Gill Engineering Services, Inc.

**Structural Audit
Repair Recommendations
Lake City, FL**

On **February 7, 2022**, per your request, Gill Engineering Services, Inc. (**GES**) conducted a structural audit of the abovementioned project. The scope of work includes a structural compliance review of the permitted drawings, identifying not compliant areas, and recommending repair to bring noted areas into FBC compliance.

1
S-301
INTERIOR FOOTER AND BEAM PLAN
SCALE: 1/8" = 1'

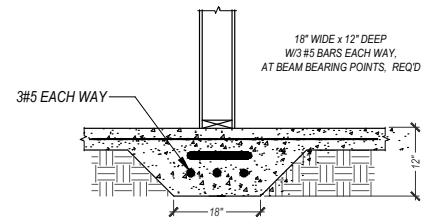
As stated by client, the concrete floor was poured without interior wall or columns footings. The permitted drawings require interior bearing wall and column footings. Listed below are structural items that need addressing. Refer to marked up "Interior Footer and Beam Plan" for wall, beams, and column designation.

1. Bearing wall referenced "BW1" requires an interior footer as noted on the permitted plans. Client drilled a hole through the concrete adjacent to the wall to demonstrate an average slab depth of 4". The plans require a minimum depth of 12" under the wall.

A new 12" deep x 12" wide footing is required under the full length of the wall. Temporarily support the attached floor trusses and remove the current wood framed wall. Saw cut and remove slab. Pour new interior footing as shown on Detail 2 Sheet S-301 of permitted drawings.

GILL ENGINEERING SERVICES, INC. AUTH #30824 GARY GILL, PE #51942 426 SW COMMERCE DR. 130-M LAKE CITY, FL 32025 386-590-1242			
BRINKLEY REPAIRS	NEW COLUMN FOOTING		
BRINKLEY			
2205-007	S-001

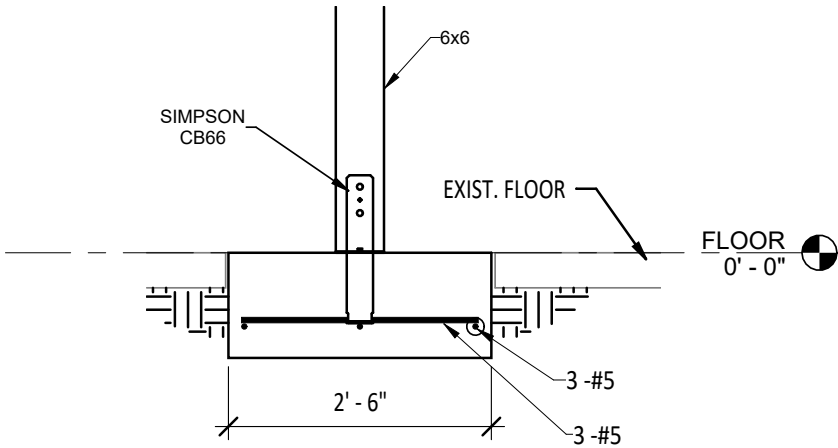
2. Column reference "C1" does not have an adequate footing and support post.

3. Column reference "C2" does not have an adequate footing and support post.

Temporary support the LVL end, remove the column, and break out concrete. Pour a new 30"x30"x12" footing and install new 6x6 post. Refer to Sketch S-001

Same as noted above.

BRINKLEY REPAIRS		GILL ENGINEERING SERVICES, INC. AUTH #30824 GARY GILL, PE #51942 426 SW COMMERCE DR. 130-M LAKE CITY, FL 32025 386-590-1242	
BRINKLEY			
INTERIOR WALL FOOTING			
2205-007	S-002

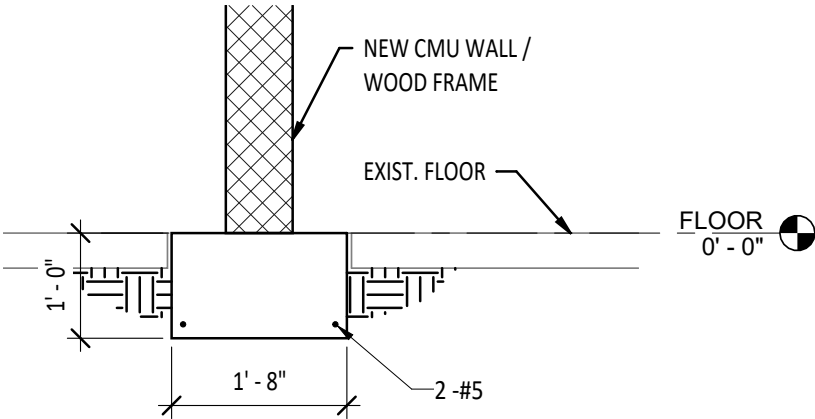
5. Bearing walls BW3, BW4, BW5, and C3 require interior footings. The plans call for the walls to be wood framed. The constructed walls are 8" CMU fully grouted.

- (a) Temporary support floor trusses as needed and remove existing CMU wall. Saw cut floor and pour new interior footing for bearing wall. Refer to SK-002 for suggested footing size and reinforcing.
- (b) Underpin the bearing walls BW3, BW4, and BW5. Refer to a Foundation Underpinning Contractor for guidance.

BRINKLEY REPAIRS		GILL ENGINEERING SERVICES, INC. AUTH #30824 GARY GILL, PE #51942 426 SW COMMERCE DR. 130-M LAKE CITY, FL 32025 386-590-1242	
		BRINKLEY	
24" LVL BEAM SUPPORT			
2205-007	S-003

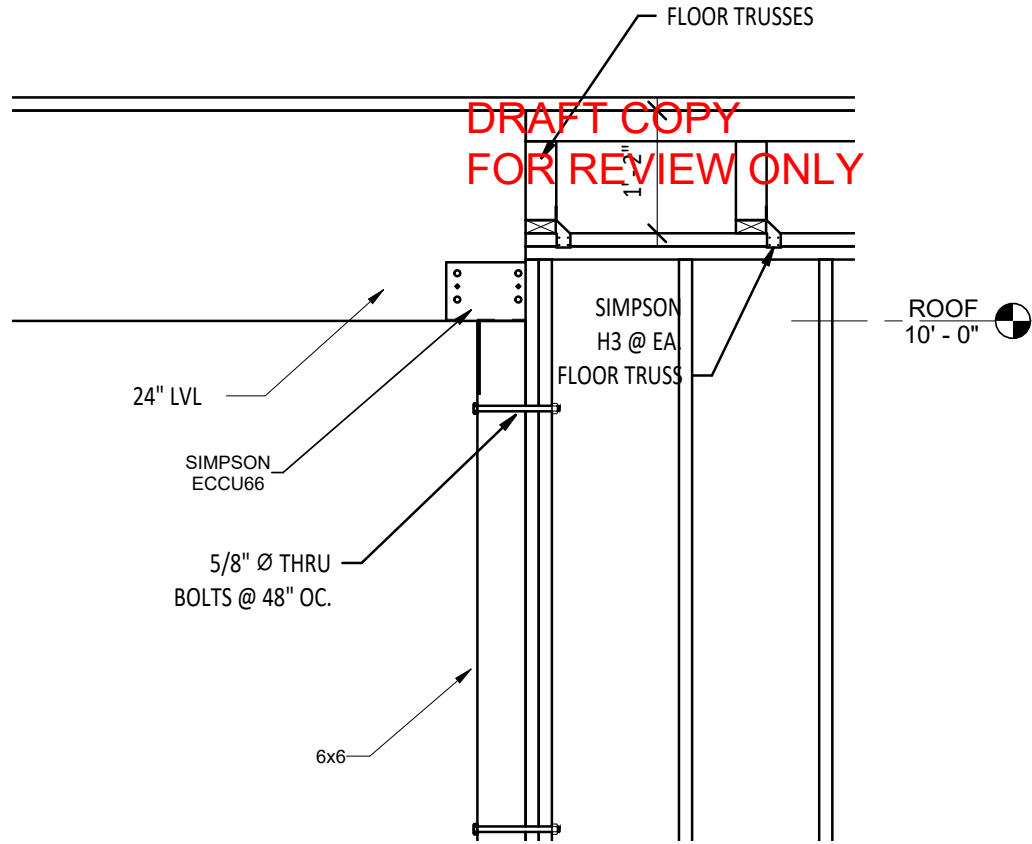
1. The 24" LVL Girder (G1) has been notched at the member end. The notch has compromised the load capacity of the girder. The span will require shortening and re-supporting

The notch needs to be removed. Shorten the length of the beam and support with new column. Refer to Repair sketch detail S-003

BRINKLEY REPAIRS		GILL ENGINEERING SERVICES, INC. AUTH #30824 GARY GILL, PE #51942 426 SW COMMERCE DR. 130-M LAKE CITY, FL 32025 386-590-1242
BRINKLEY		
WALL REINFORCEMENT		
2205-007	S-004

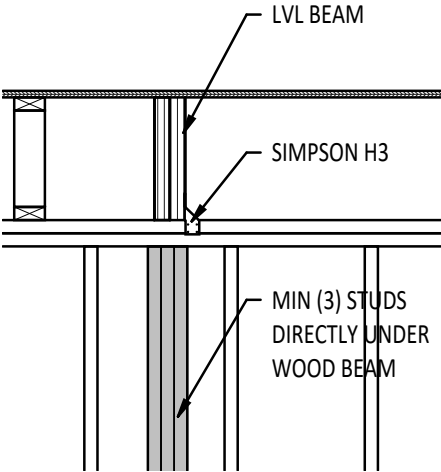
3. Owner to verify the (2) ply 14" LVL bearing on the CMU wall is pressure treaded. If not, separation between the two is required.
4. The LVL ends bearing on the exterior wall (wood framed) requires jack studs directly under the LVL beam.

Add additional 2x studs under LVL beam. Refer to Sketch S-004
